MARK	DATE	DESCRIPTIONS	BY	CH'D	CCO#
0	05/06/11	MEP INTEGRATION REV. & UPGRADES TO SYSTEMS	TW	RG	163

CONTRACT CHANGE ORDER NO. 163
SHEET 3 OF 32

SKYWAY ROADWAY LEVEL EASTBOUND LIGHTING AND ELECTRICAL SYSTEMS

DETAIL-1
(TYP. FOR EACH BIKE PATH LIGHTING)

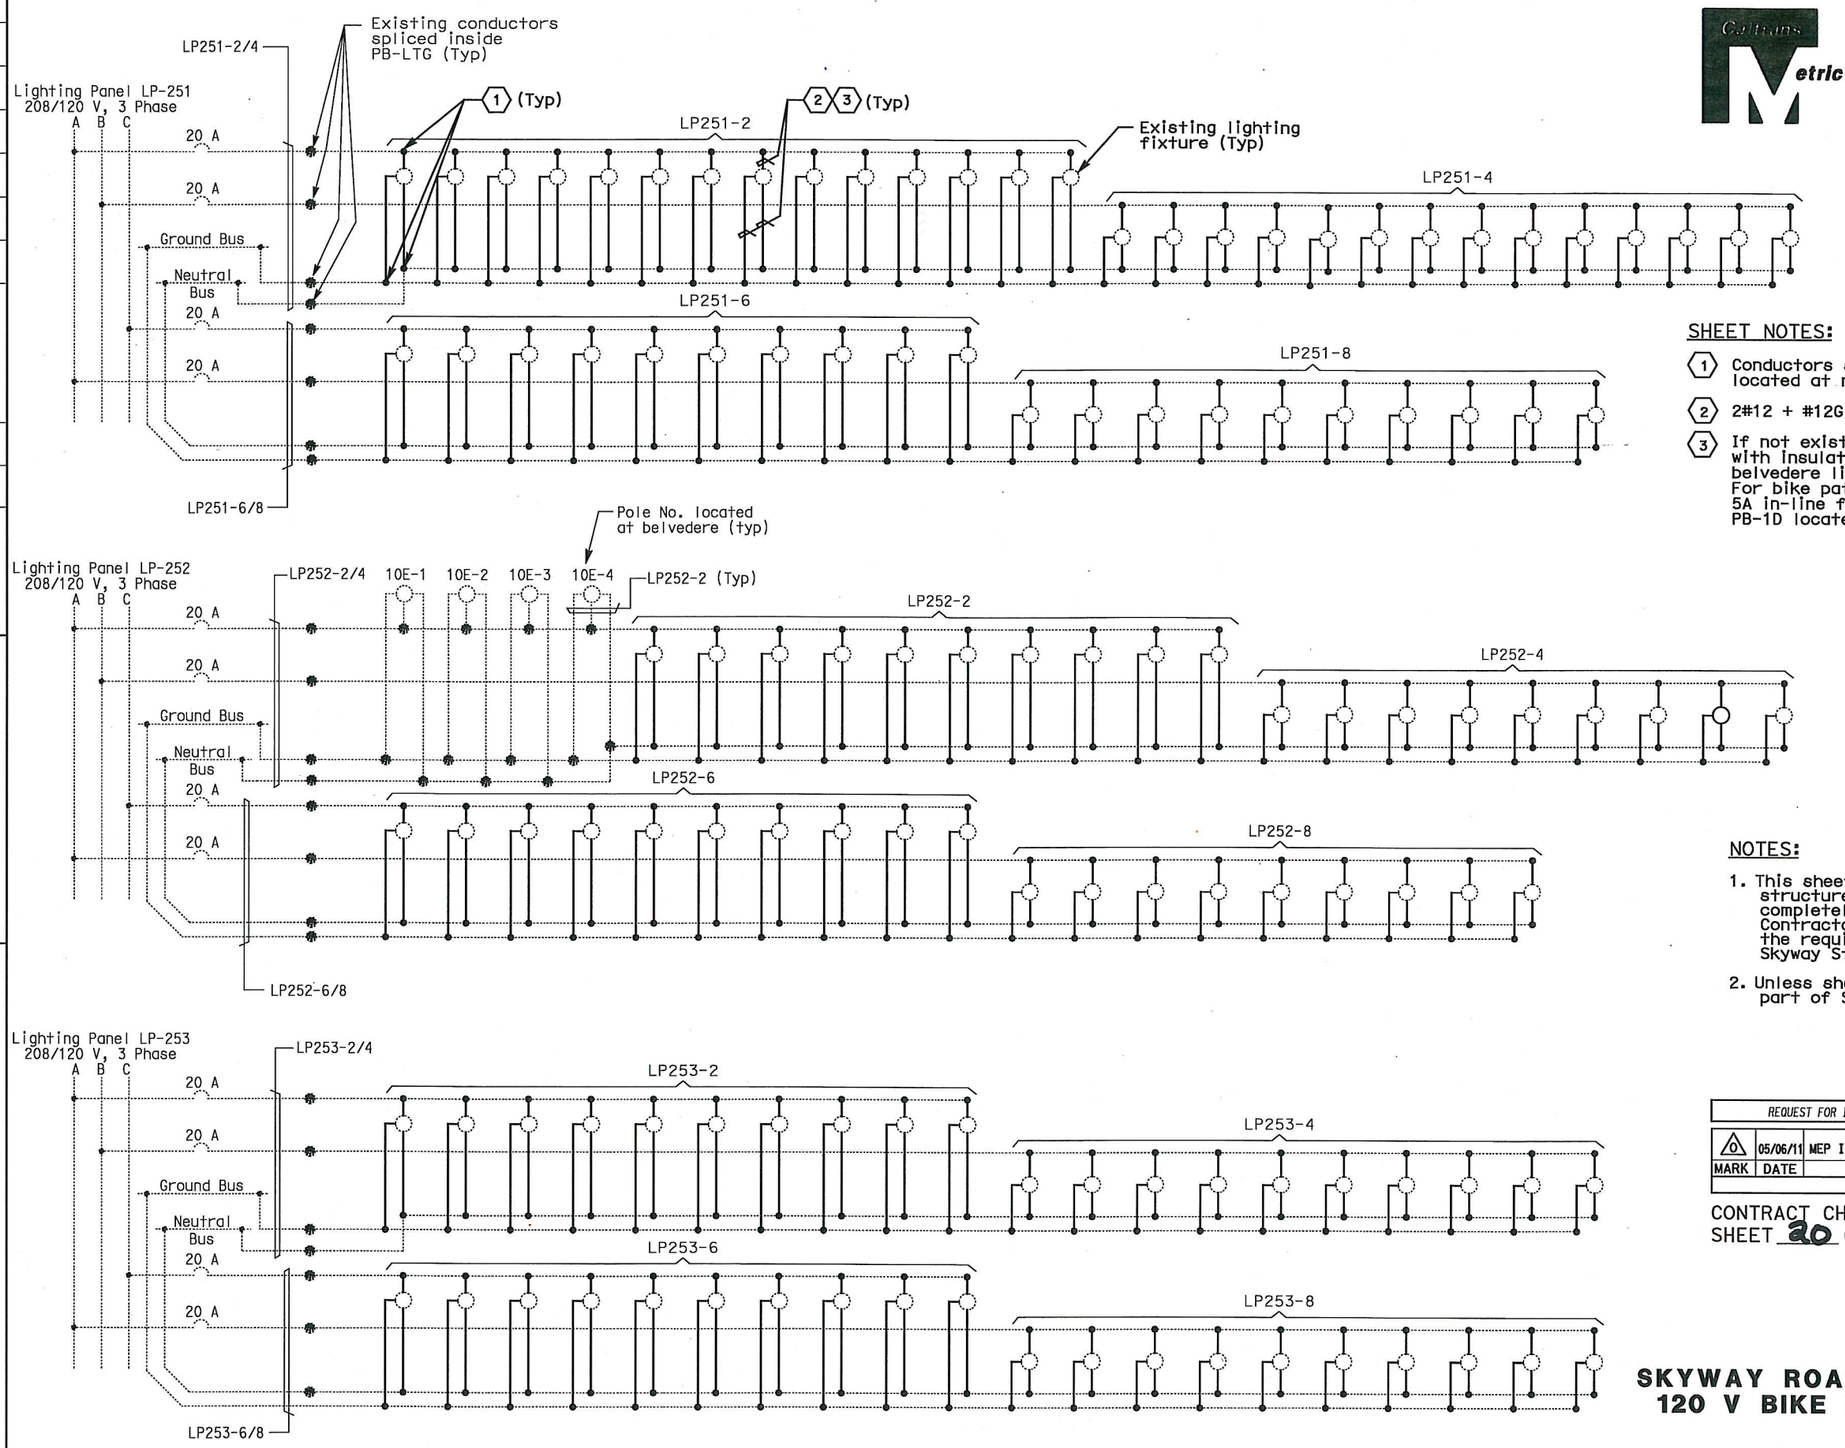
1. Conductors spliced inside PB-LTG (PB-1D) located at north side of Bike Path.
2. 2#12 + #12G, THWN. See Detail 1.
3. If not existing, install 5A in-line fuse in fuseholder with insulating boot per light fixture inside the belvedere light pole handhole for 10E-1 through 10E-4. For bike path lights (north/south hand railing) install 5A in-line fuses with water resistant fuseholder inside PB-1D located at north side of the bike path.

DETAIL-1
(TYP. FOR EACH BIKE PATH LIGHTING)

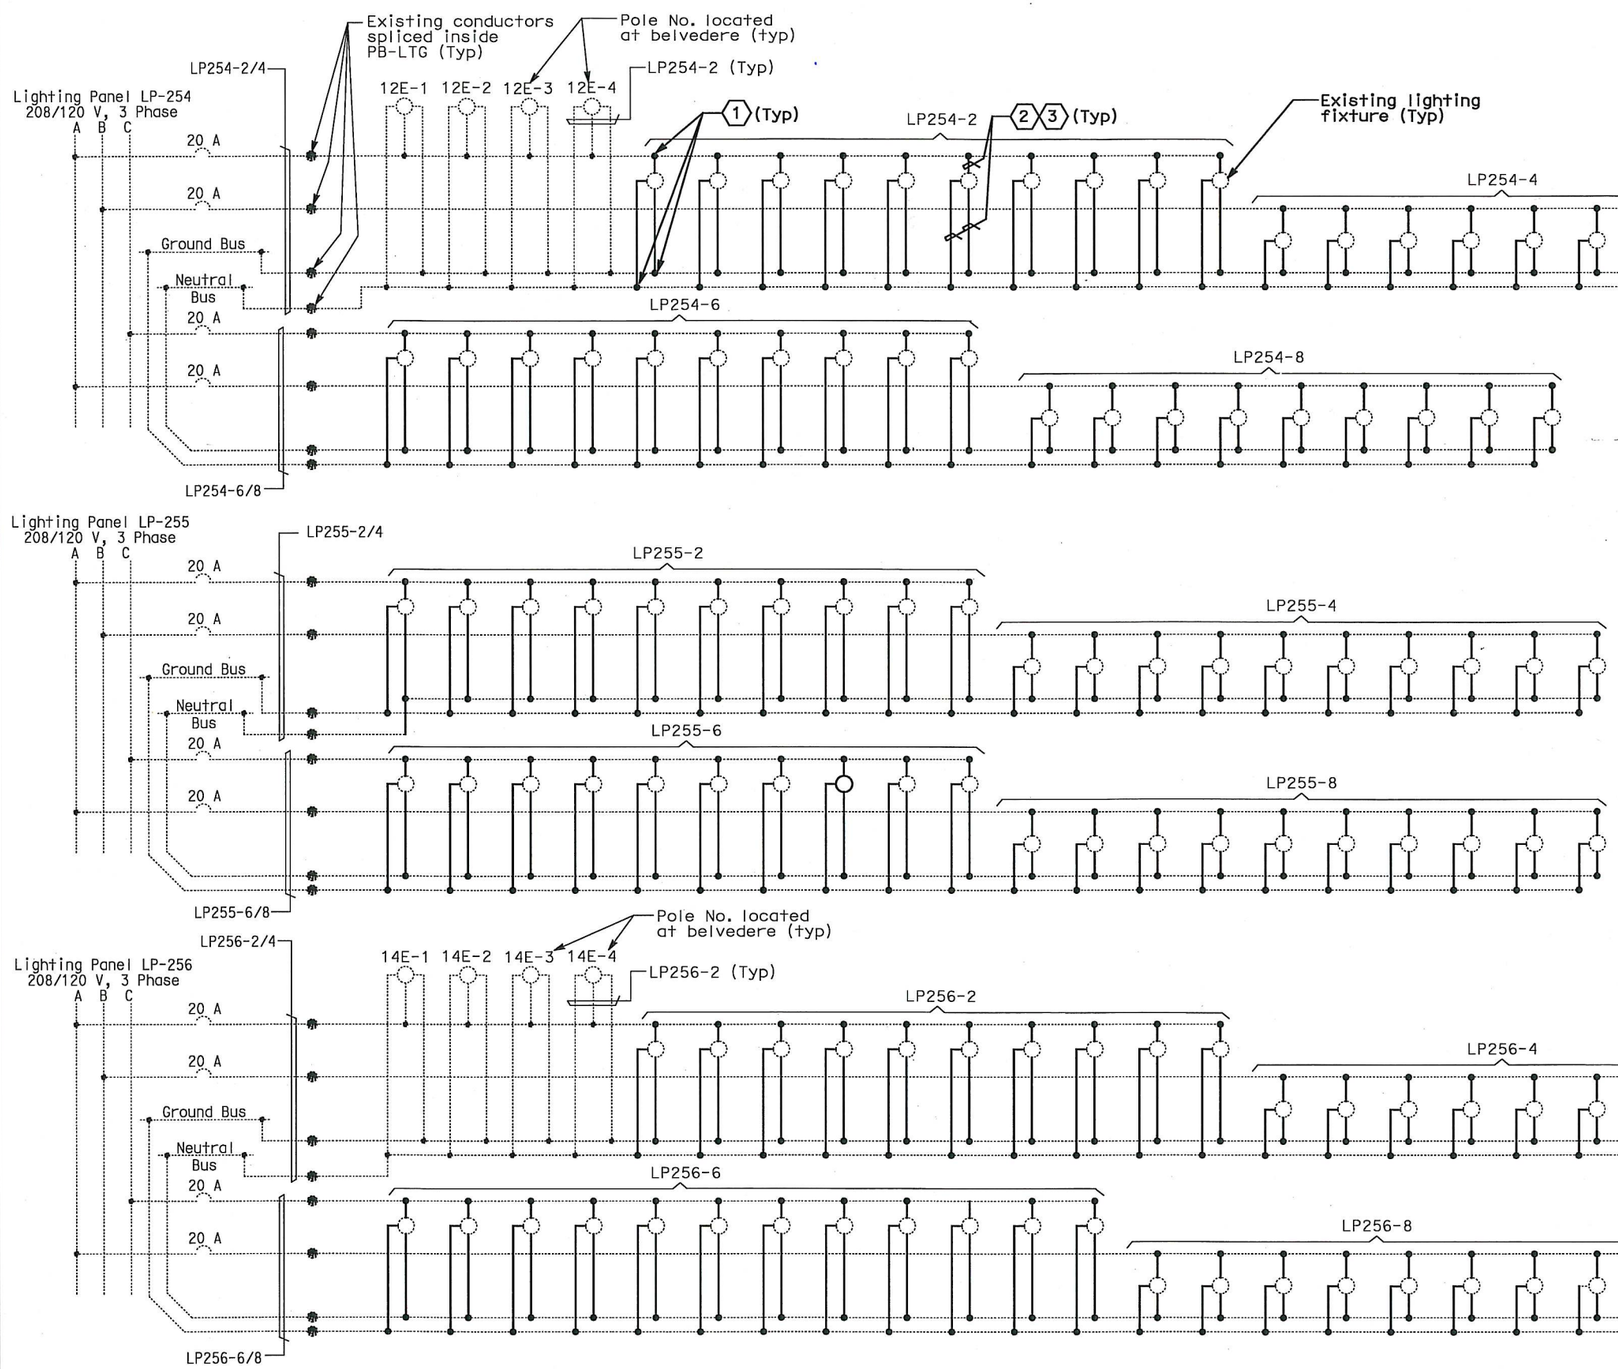
1. Conductors spliced inside PB-LTG (PB-1D) located at north side of Bike Path.
2. 2#12 + #12G, THWN. See Detail 1.
3. If not existing, install 5A in-line fuse in fuseholder with insulating boot per light fixture inside the belvedere light pole handhole for 14E-1 through 14E-4. For bike path lights (north/south hand railing) install 5A in-line fuses with water resistant fuseholder inside PB-1D located at north side of the bike path.

DETAIL-1
(TYP. FOR EACH BIKE PATH LIGHTING)

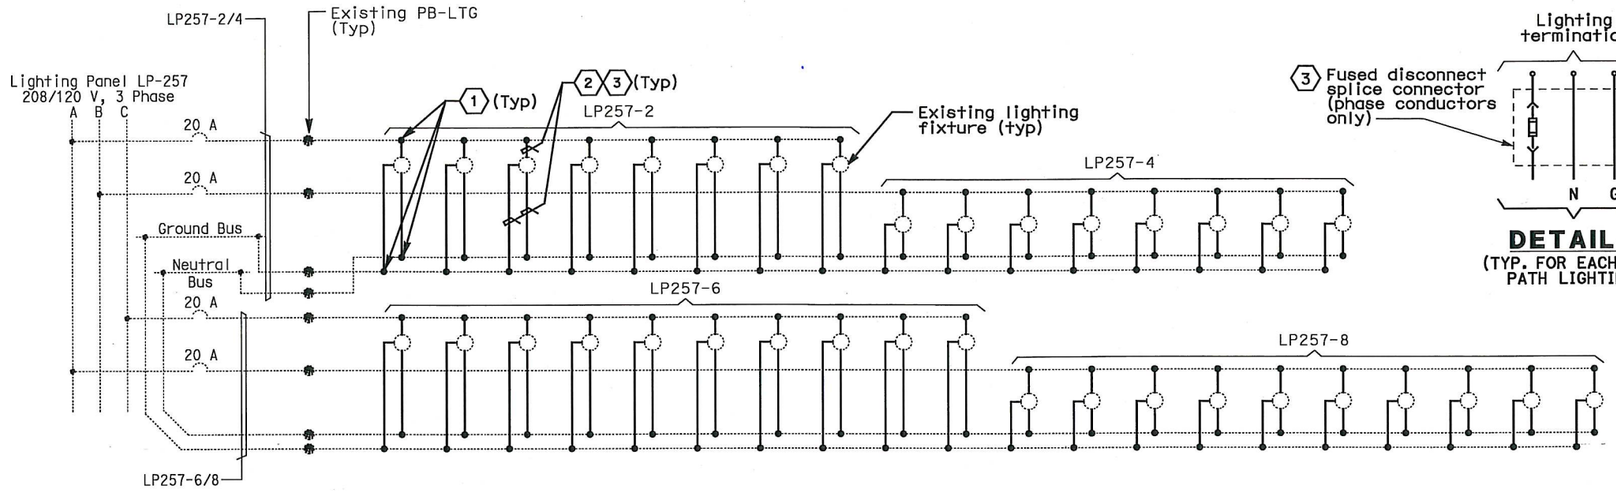
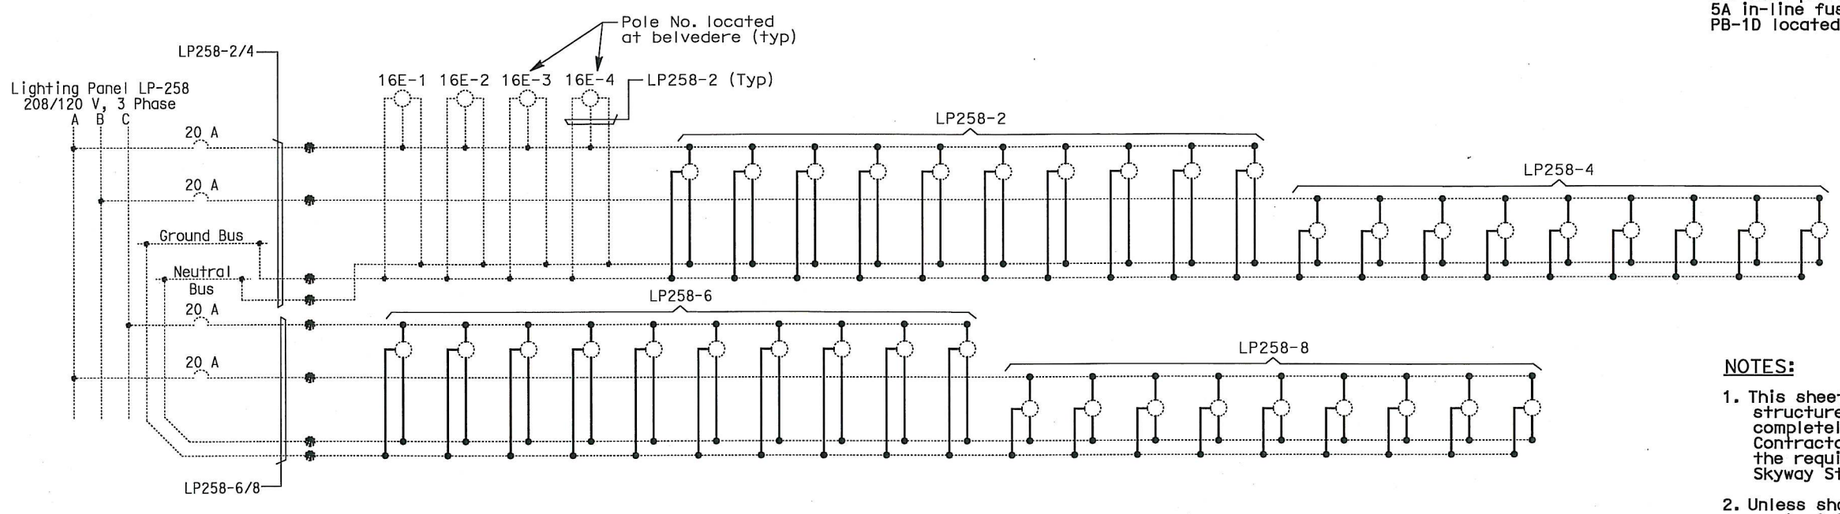
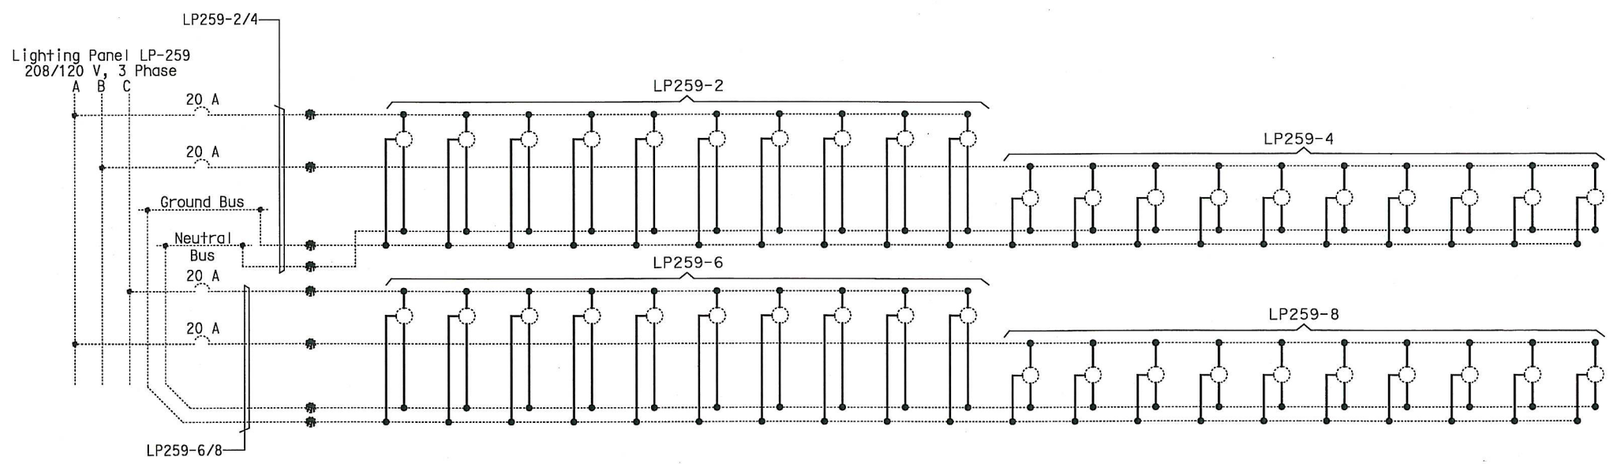
1. Conductors spliced inside PB-LTG (PB-1D) located at north side of Bike Path.
2. 2#12 + #12G, THWN. See Detail 1.
3. If not existing, install 5A in-line fuse in fuseholder with insulating boot per light fixture inside the belvedere light pole handhole for 16E-1 through 16E-4. For bike path lights (north/south hand railing) install 5A in-line fuses with water resistant fuseholder inside PB-1D located at north side of the bike path.

DETAIL-1
(TYP. FOR EACH BIKE PATH LIGHTING)

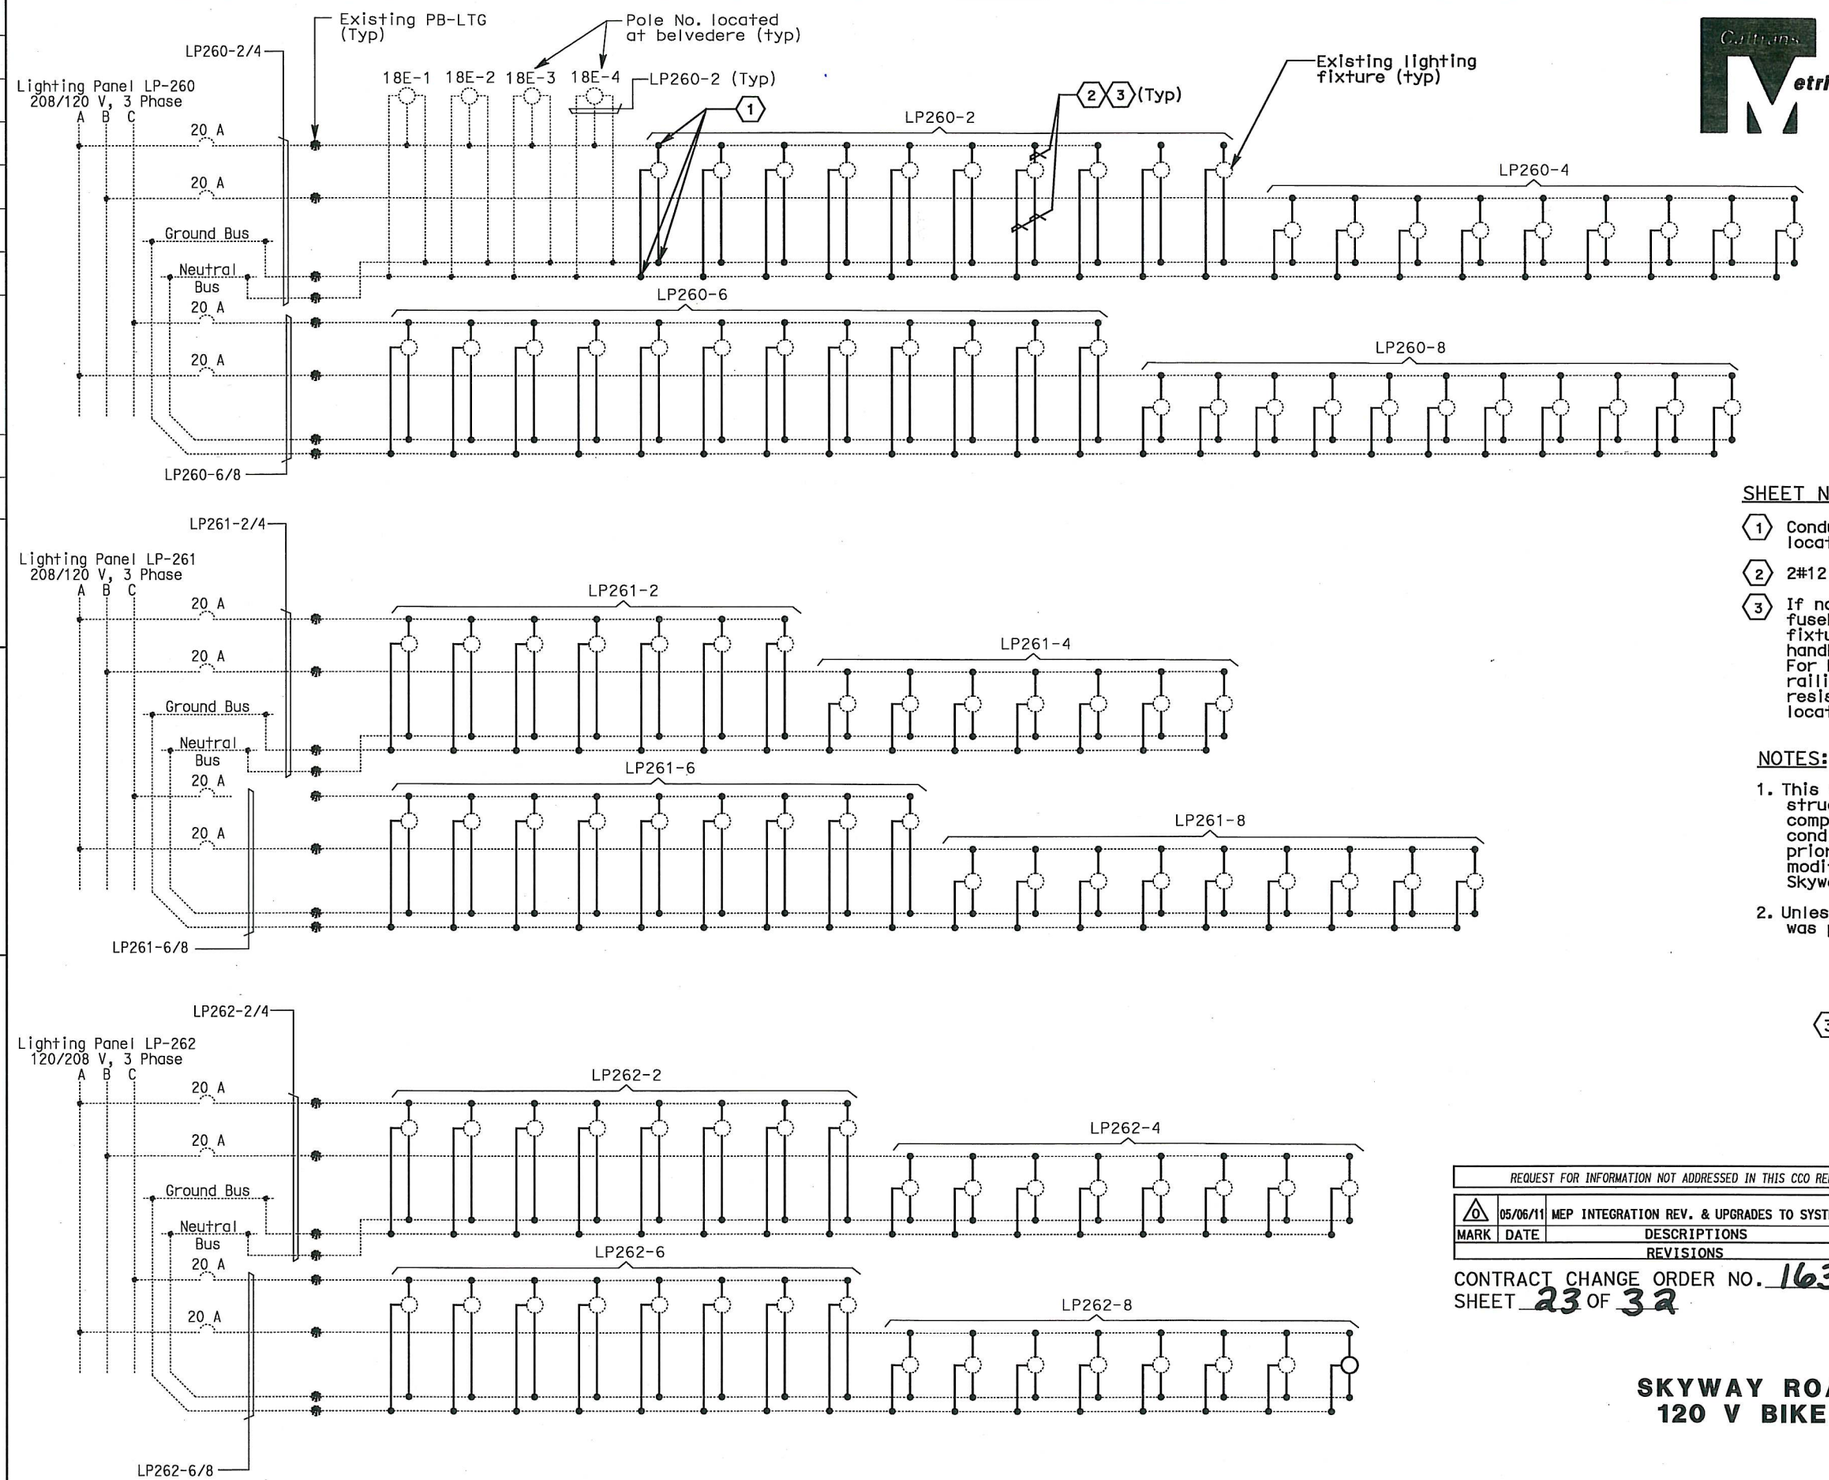
1. Conductors spliced inside PB-LTG (PB-1D) located at north side of Bike Path.
2. 2#12 + #12G, THWN. See Detail 1.
3. If not existing, install 5A in-line fuse in fuseholder with insulating boot per light fixture inside the belvedere light pole handhole for 18E-1 through 18E-4. For bike path lights (north/south hand railing) install 5A in-line fuses with water resistant fuseholder inside PB-1D located at north side of the bike path.

DETAIL-1
(TYP. FOR EACH BIKE PATH LIGHTING)

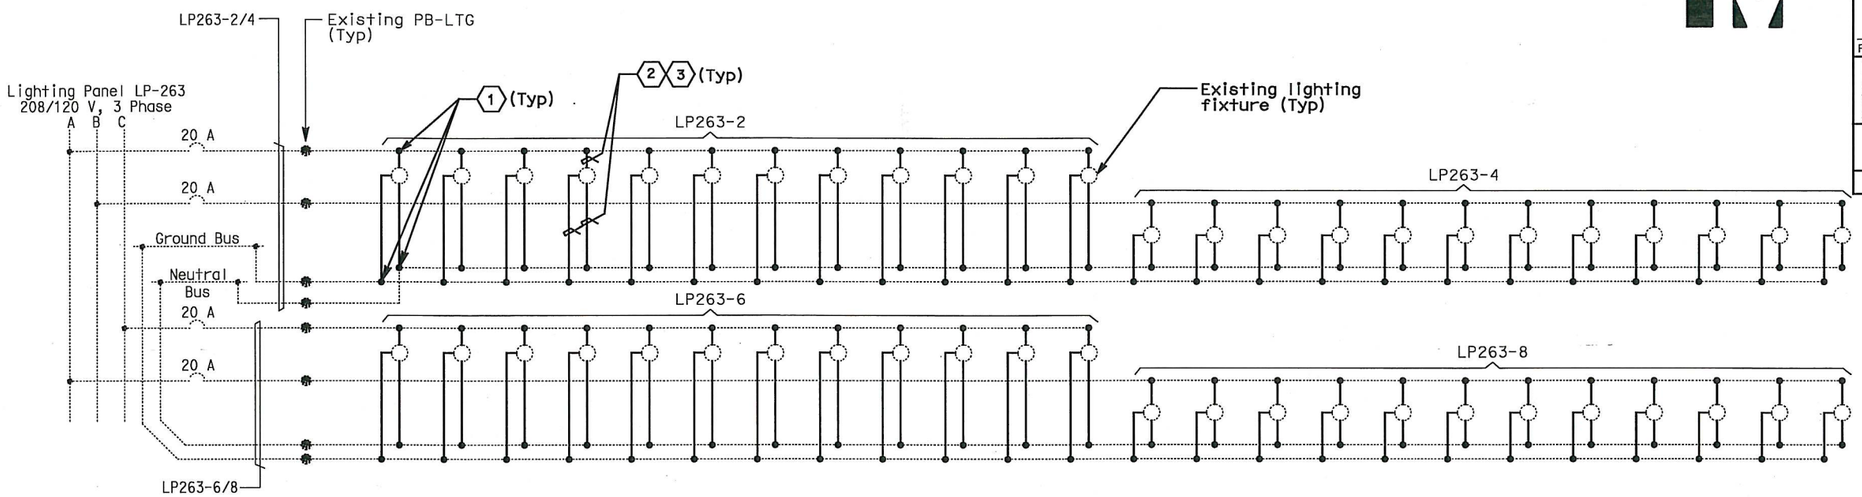
1. Conductors spliced inside PB-LTG (PB-1D) located at north side of Bike Path.
2. 2#12 + #12G, THWN. See Detail 1.
3. For bike path lights (north/south hand railing) install 5A in-line fuses with water resistant fuseholder inside PB-1D located at north side of the bike path.
